PRELIMINARY APPROVAL DEVELOPMENT PLAN

COSTCO WHOLESALE

SITE LAYOUT PLAN
DATE: JUNE 2015
DRAWN BY: JRM
CHECKED BY: JRM
AS NOTED
APPROVED BY: (HAND SIGNATURE ON FILE) (JRM)
DAR 143-902
SCALE: 1" = 40' (SEE PLAN FOR STALL DEPTHS)
PARKING STALL COUNT (HANDICAP): 14
EXISTING SANITARY SEWER DRAIN
EXISTING WATERLINE
EXISTING STORM LINE
PROPOSED SURFACE FLOW DIRECTION
TEMPORARY CONSTRUCTION ENTRANCE
INLET PROTECTION
PROPOSED SILT FENCE
DRAWING NO.: C200

Case No. 15ZONE1008 Binding Elements

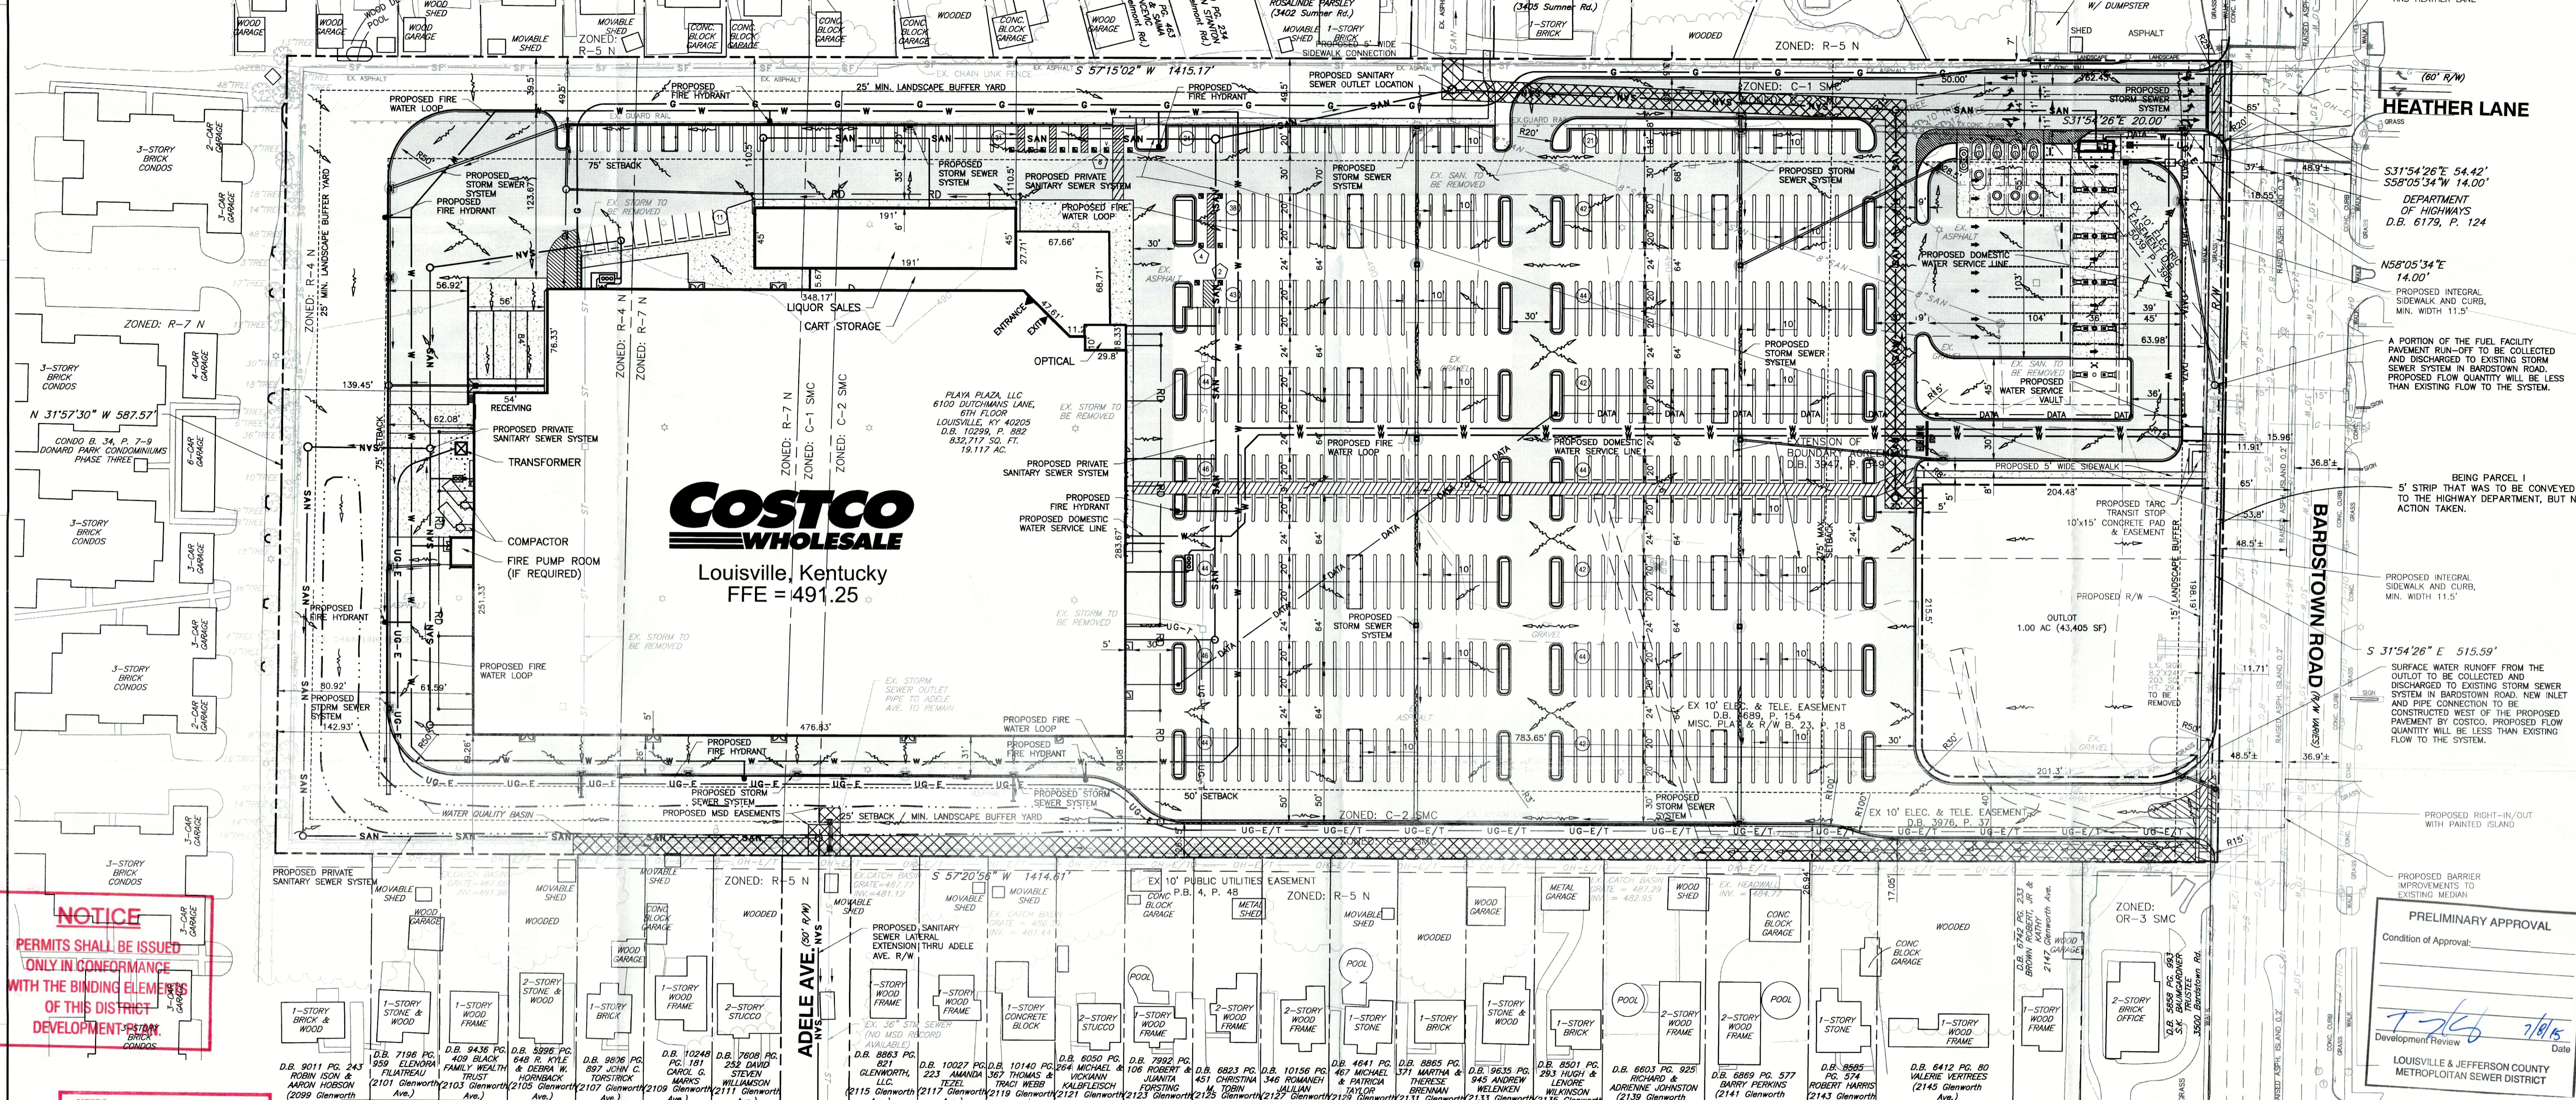
Transportation Planning requested a 3-way stop to protect pedestrians at the crosswalk near the site. Any signal modifications must be the responsibility of the developer. Lane assignments at the signal on site will have a direct relationship to the signal.
